STRUCTURES DESIGN BULLETIN C11-08

SUBJECT: Implementation of new Design Standards, Design Guidelines and Construction Specifications for Polymeric Bridge Fender Systems

This bulletin implements new requirements for Bridge Fender Systems.

Design Standards Indexes 21900, 21910, 21920 and 21930 have been removed and replaced in the July 2011 Interims with the drawings as shown in Attachment A as listed below.

**SECTION E-E
 TYPICAL STRAIGHT SECTION
 FENDER SYSTEM DETAILS**

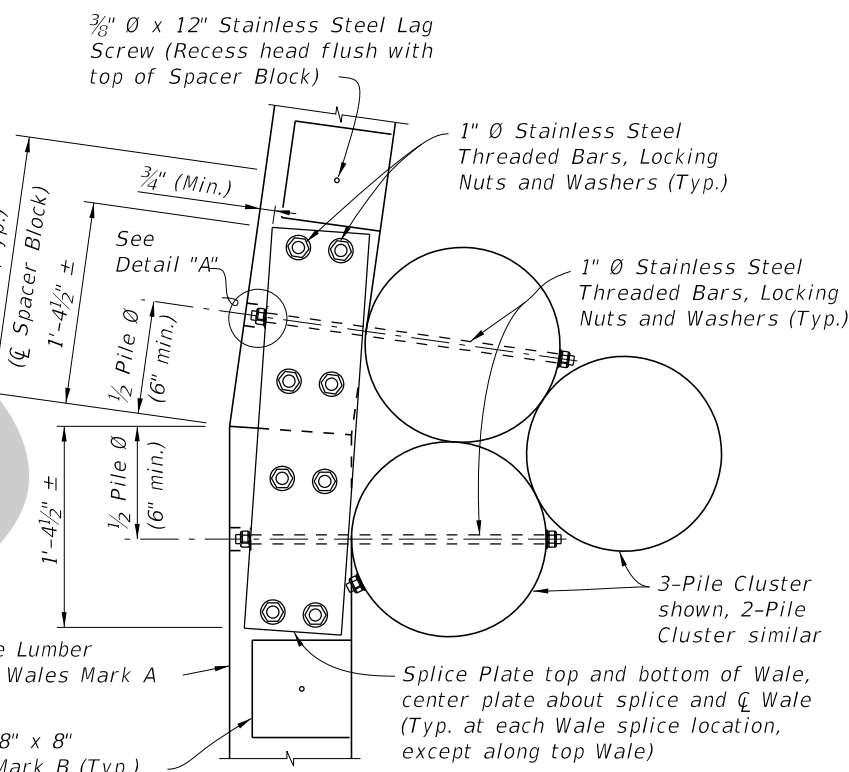
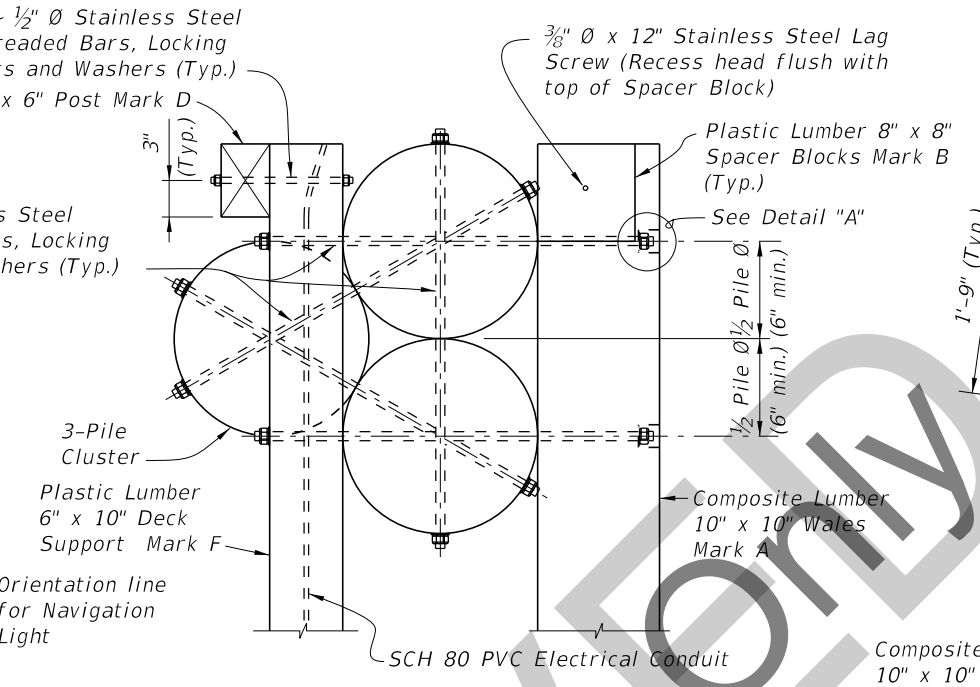
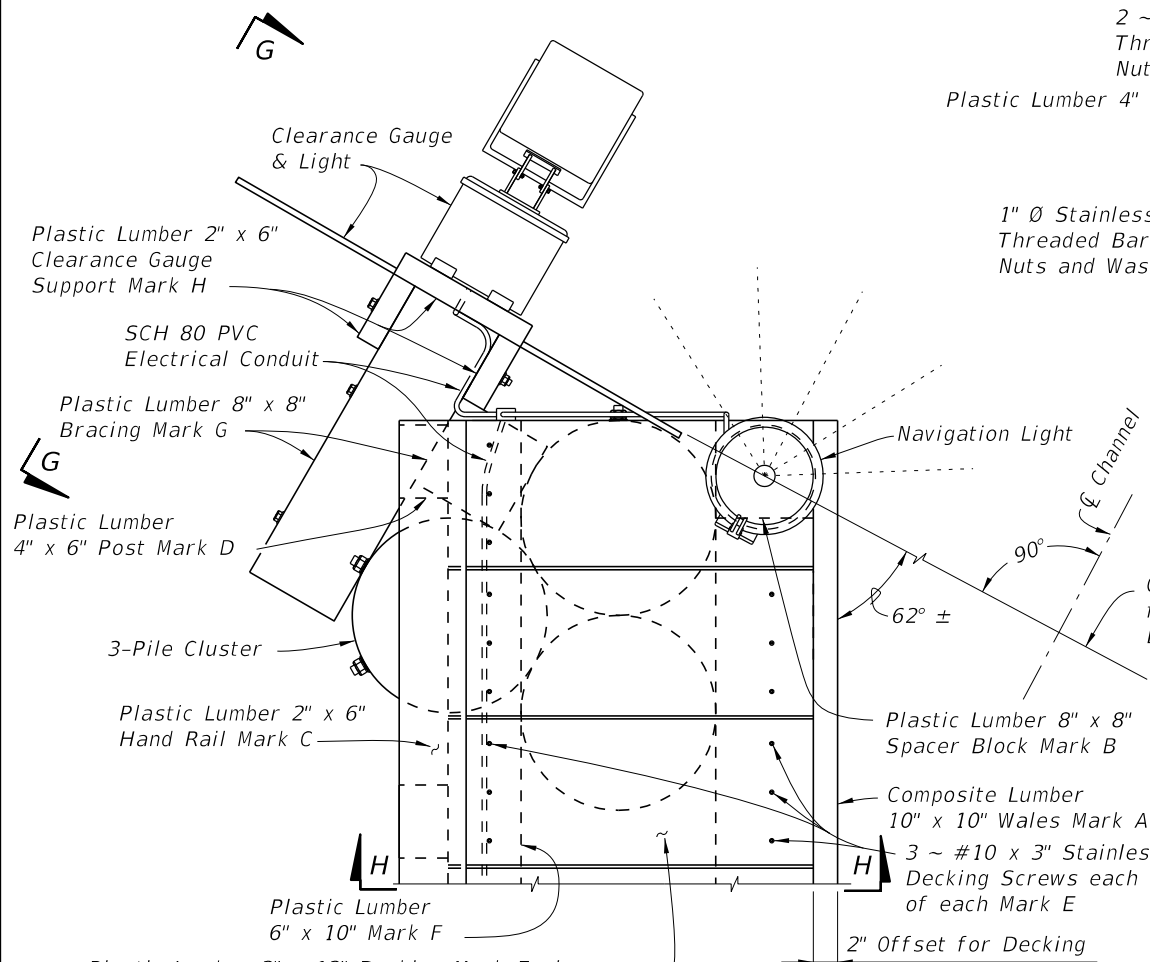
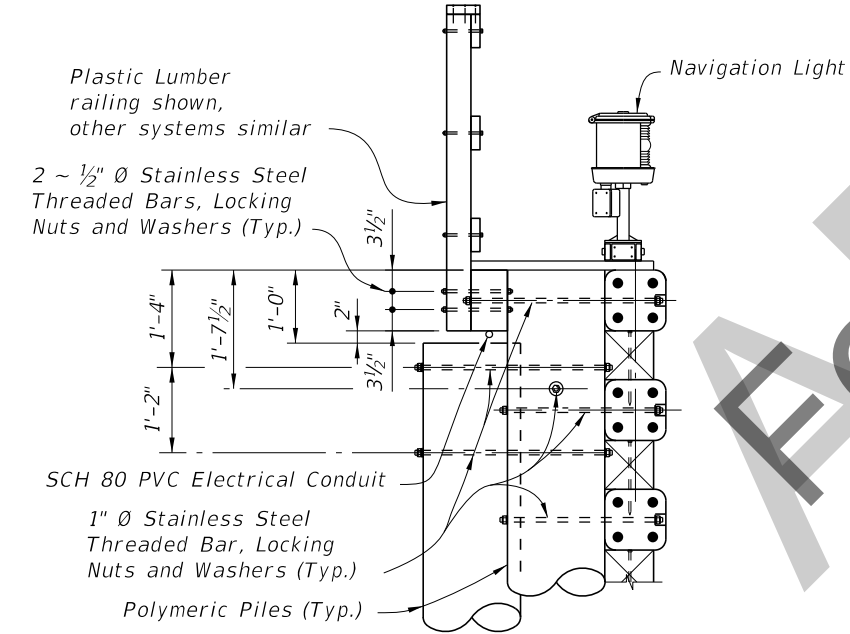
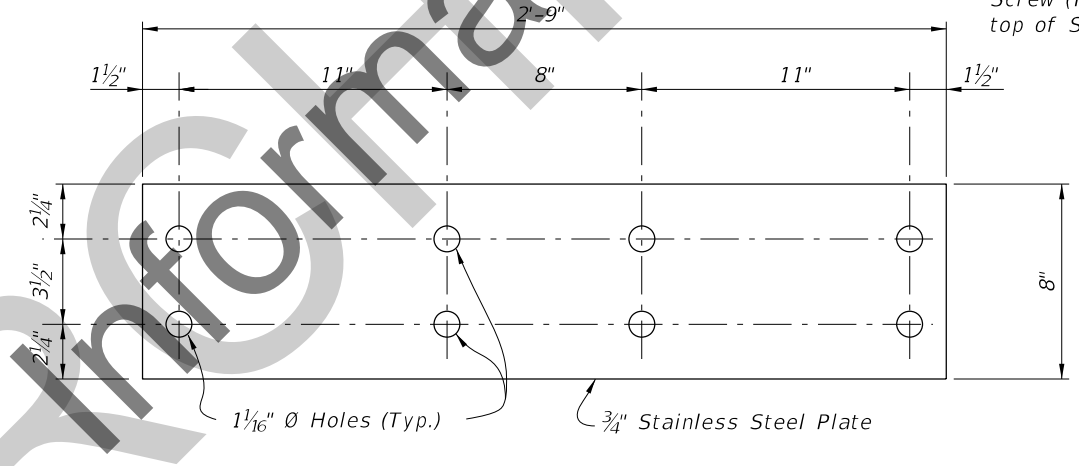
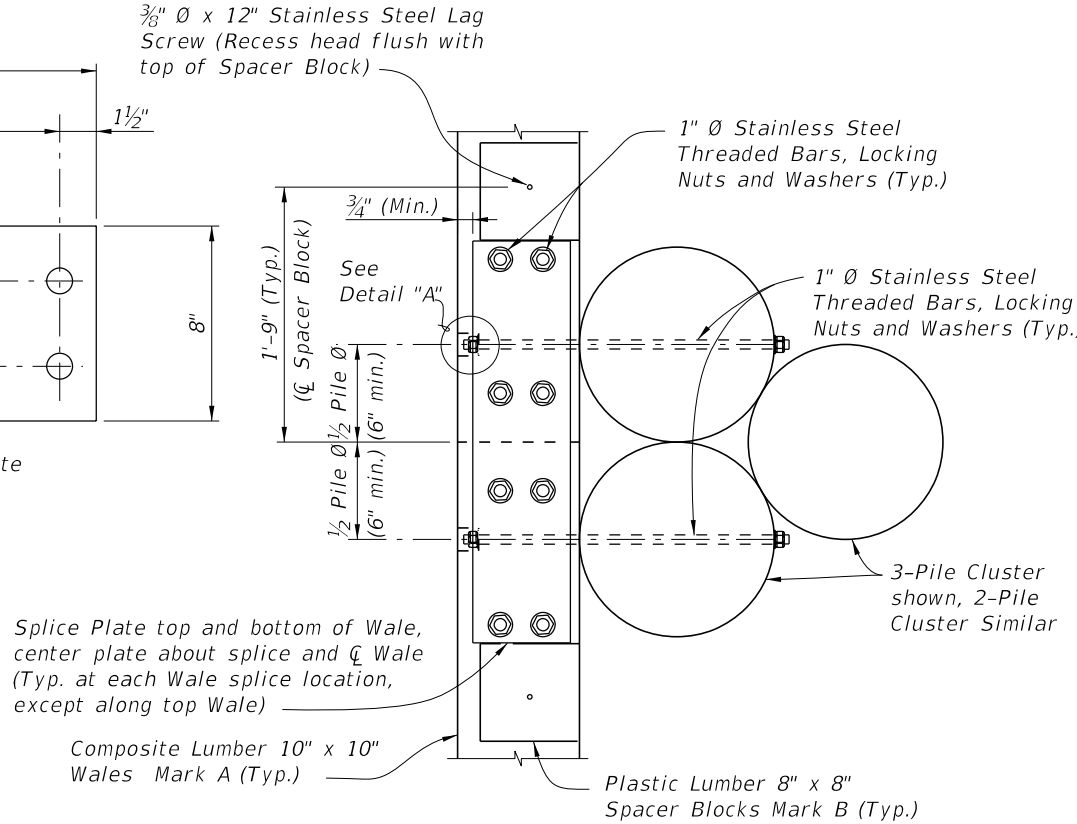
DATE	BY	DESCRIPTION	DATE	BY	DESCRIPTION
07/01/11	GJM	New Sheet (Previously Index 21910, Sheet 3); Modified to allow for various pile types and sizes; Changed bolt configurations for connection of Mark D to Mark F. Modified dimensions of splice plate.

FENDER SYSTEM DETAILS

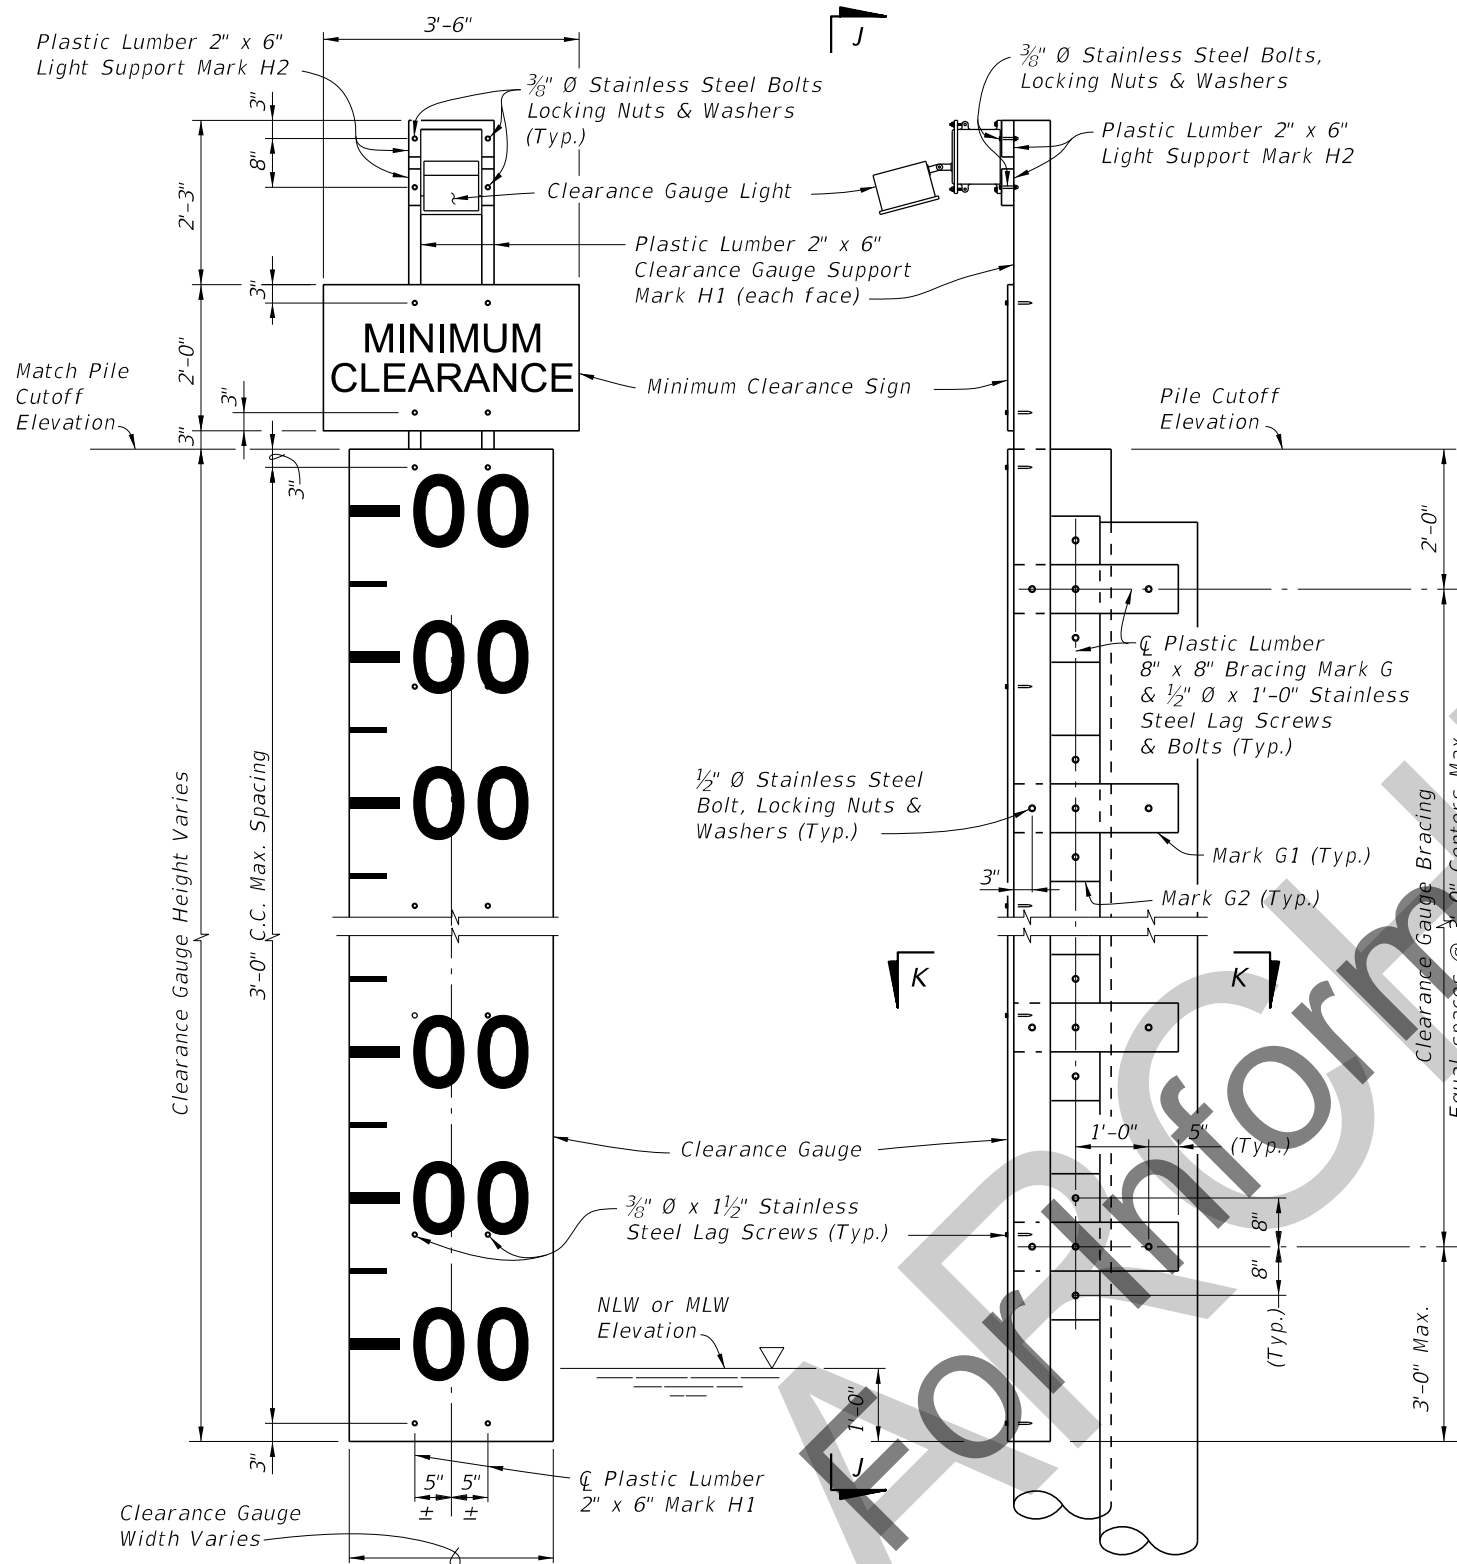
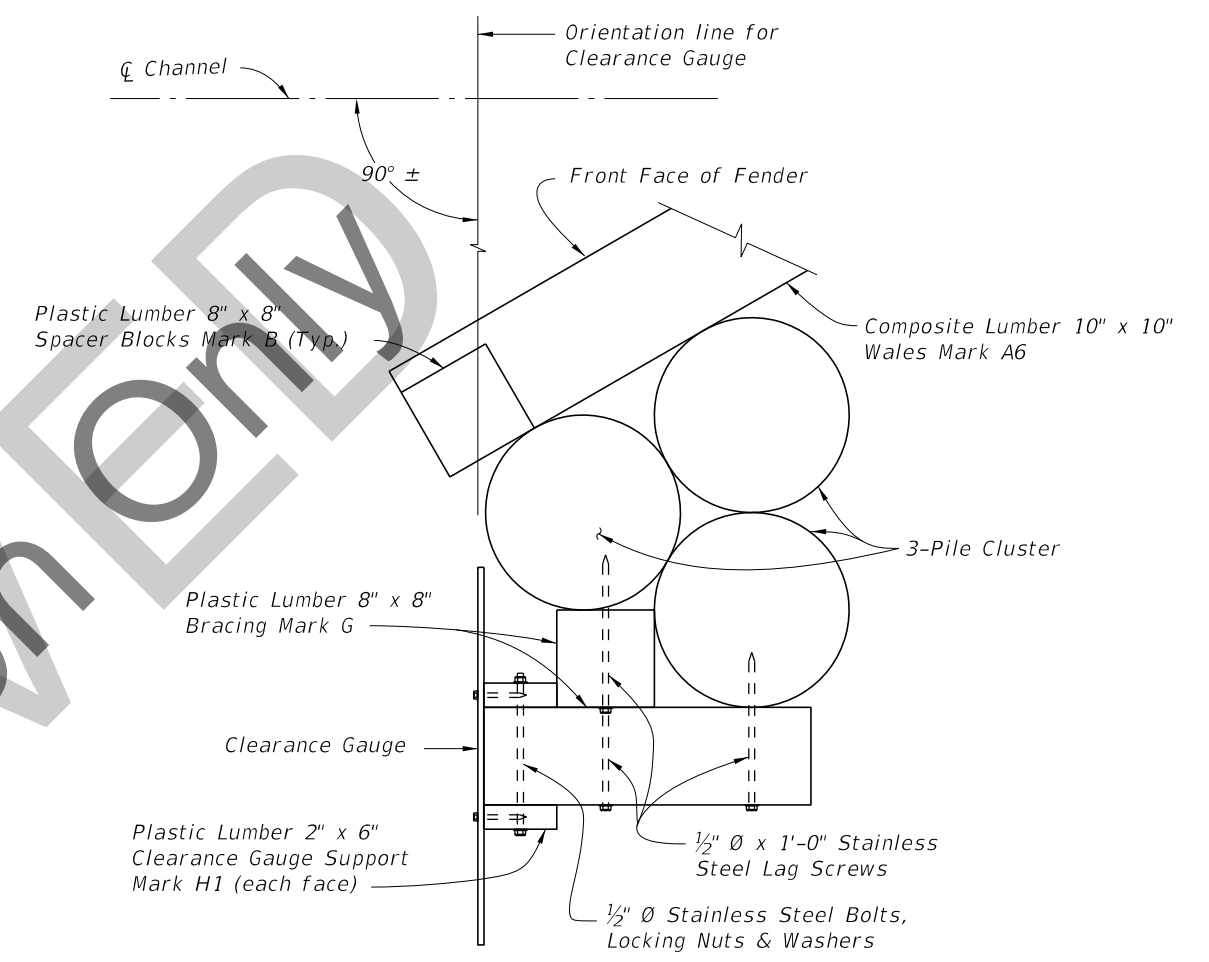
REVISIONS			
DATE	BY	DESCRIPTION	
07/01/11	GJM	New Sheet (Previously Index 21910, Sheet 4); Modified to allow for various pile types and sizes.

LAYOUT GEOMETRY

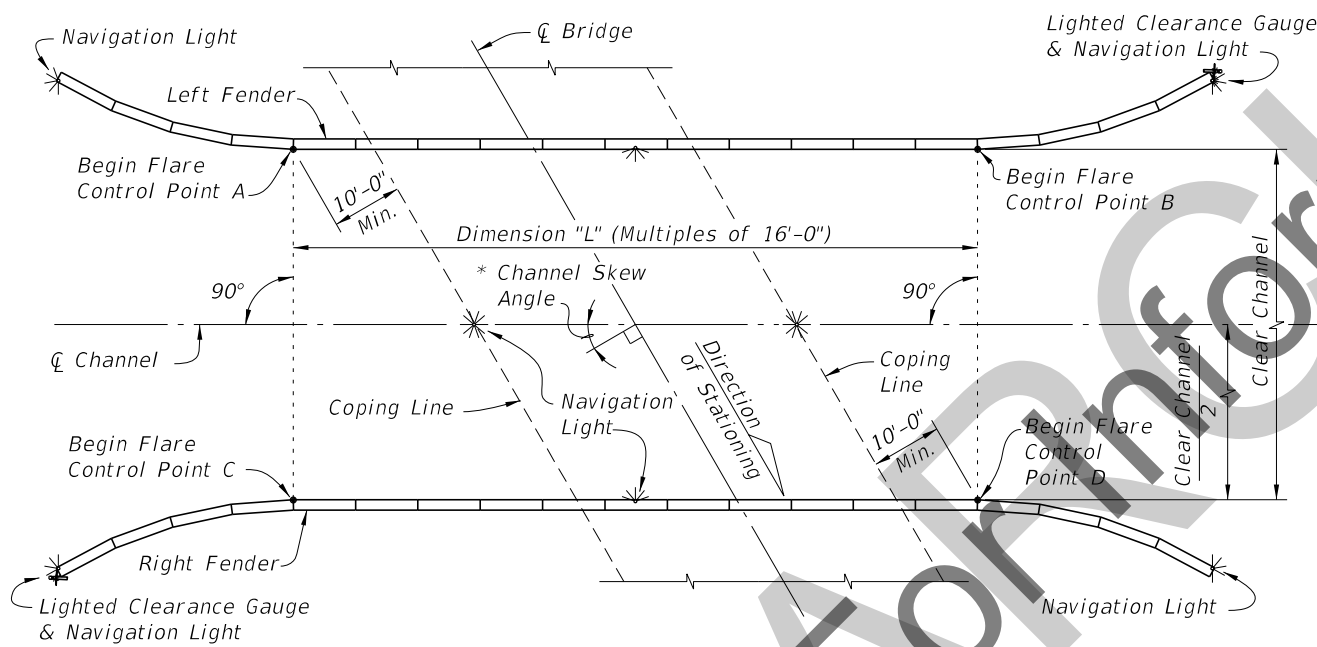
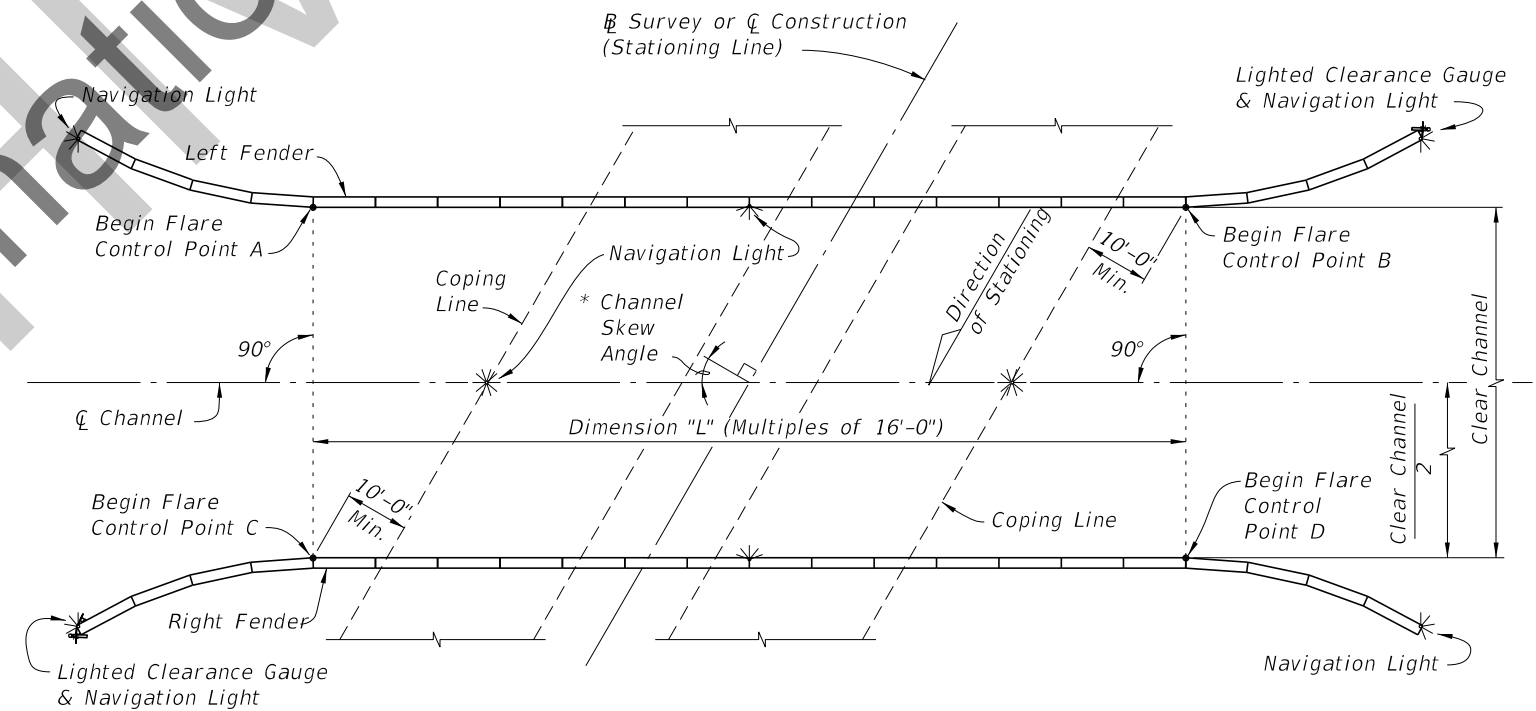
REVISIONS			
DATE	BY	DESCRIPTION	
07/01/11	GJM	New Sheet; Added Schematic details to separate this Index from polymeric piling fenders.
